Millstone Nuclear Power Station, Unit No. 2
Proposed Revisions to Technical Specifications

August, 1980

Technical Specification Changes - Cycle 4 Reload

FIGURE 2.1-1 Reactor Core Thermal Margin Safety Limit - Four Reactor Coolant Pumps Operating

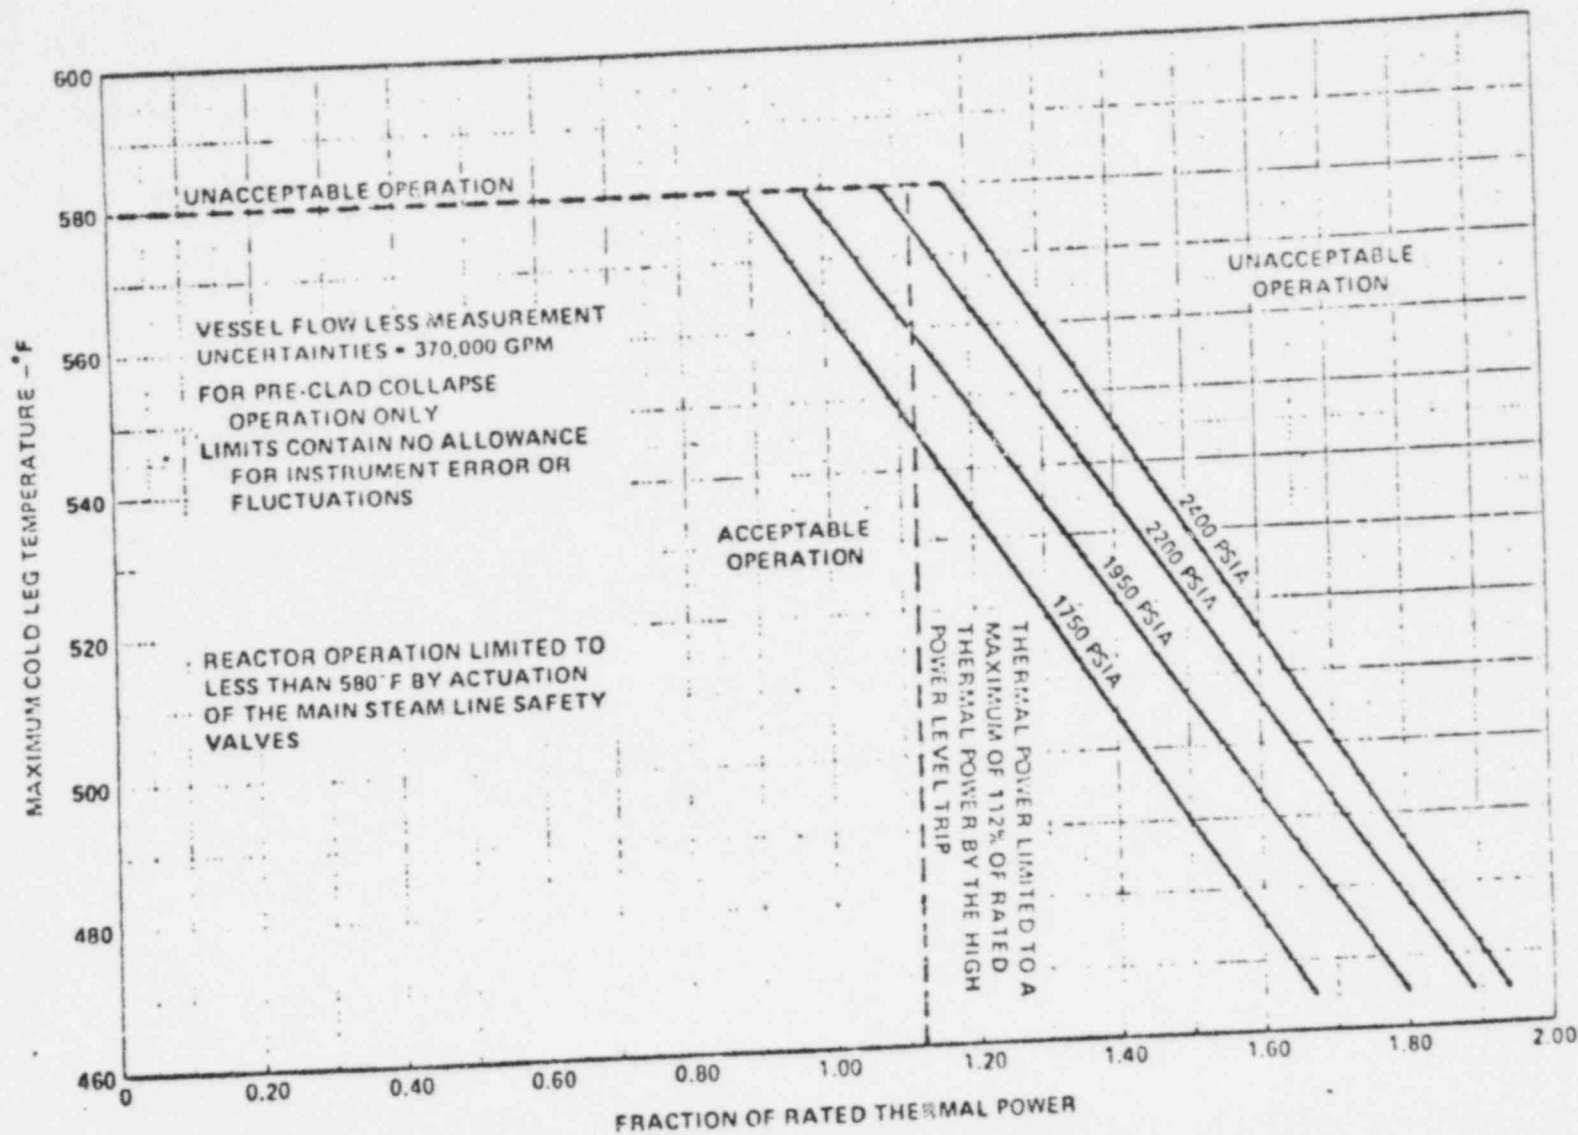
- (2) The information presented on Figure 2.1-1 on page 2-2 has been revised to reflect the deletion of Figure B 2.1-1 on page B 2-2. The axial power distributions illustrated in Figure B 2.1-1 were valid for the previous vendor's analyses. The Westinghouse axial power distribution

methodology is utilized to produce Figure 2.1-1. It is therefore, inappropriate to include Figure B 2.1-1 in the Cycle 4 Technical Specifications.

Figure 4.2-1
Augmentation Factors Vs. Distance
From Bottom of Core

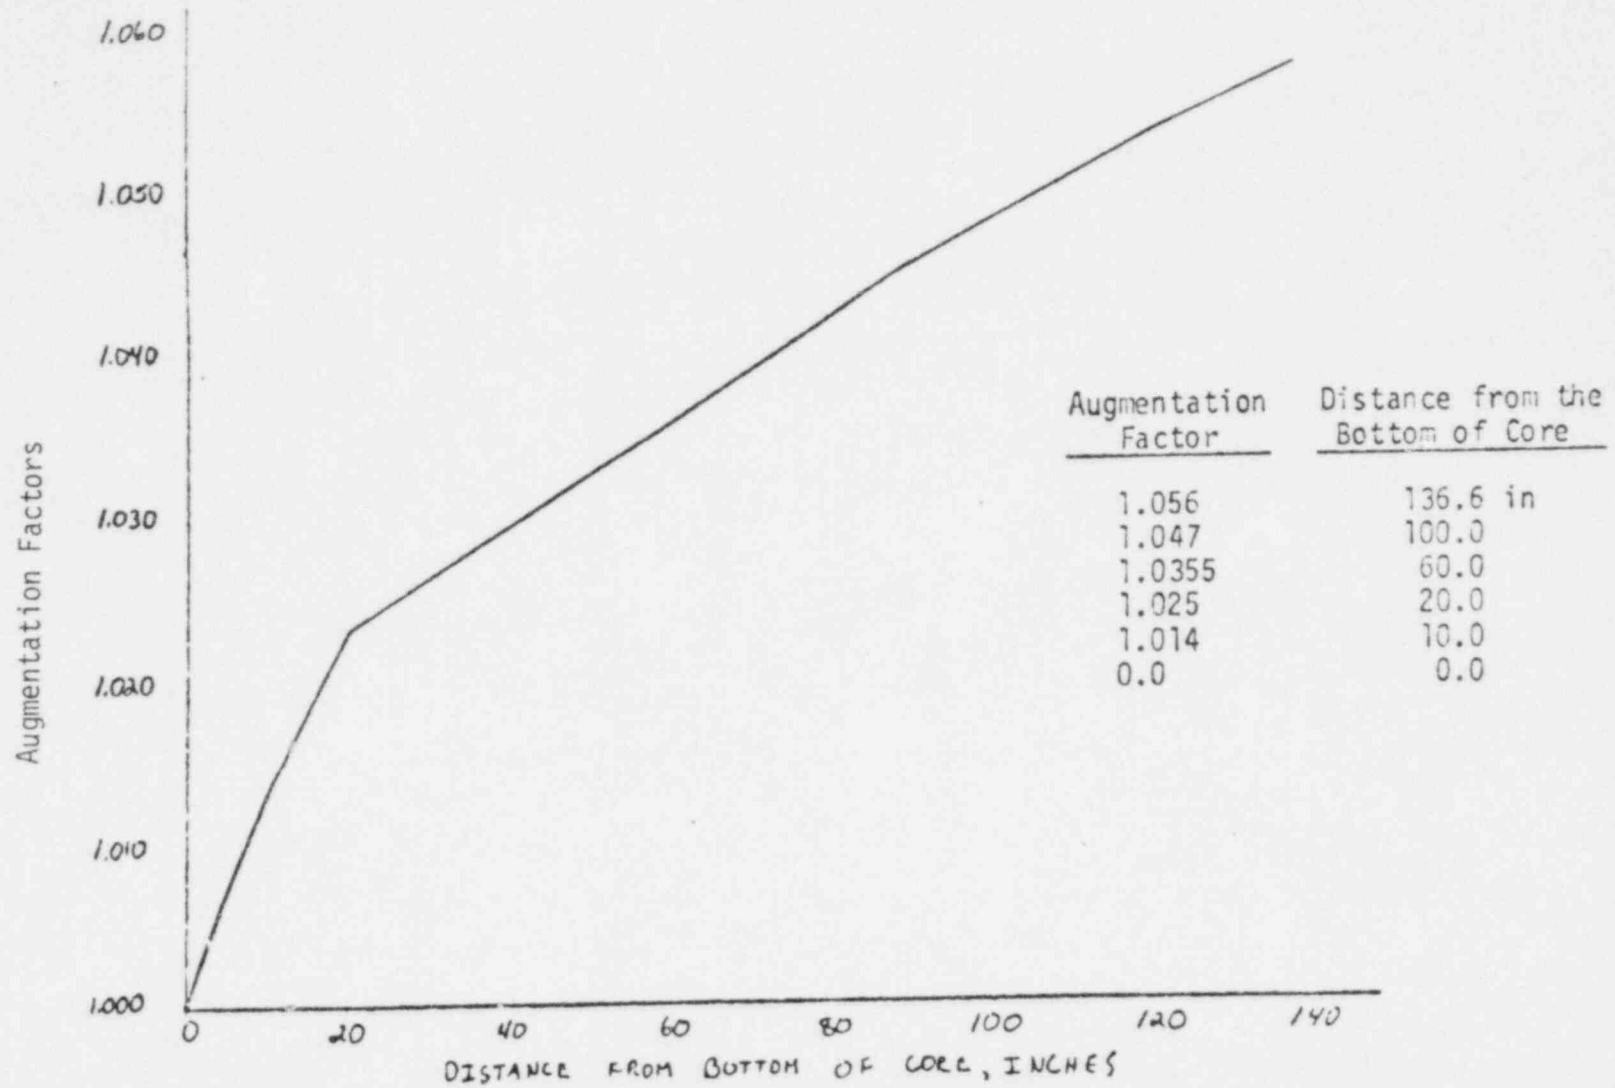
- (8) Figure 4.2-1 on page 3/4 2-5 has been revised to reflect the augmentation factors which will apply to the Westinghouse Batch F fuel during Cycle 4. The proposed augmentation factors presented in the attached Figure 4.2-1 envelop the previous cycles' factors and will therefore be utilized for the entire Cycle 4 core.
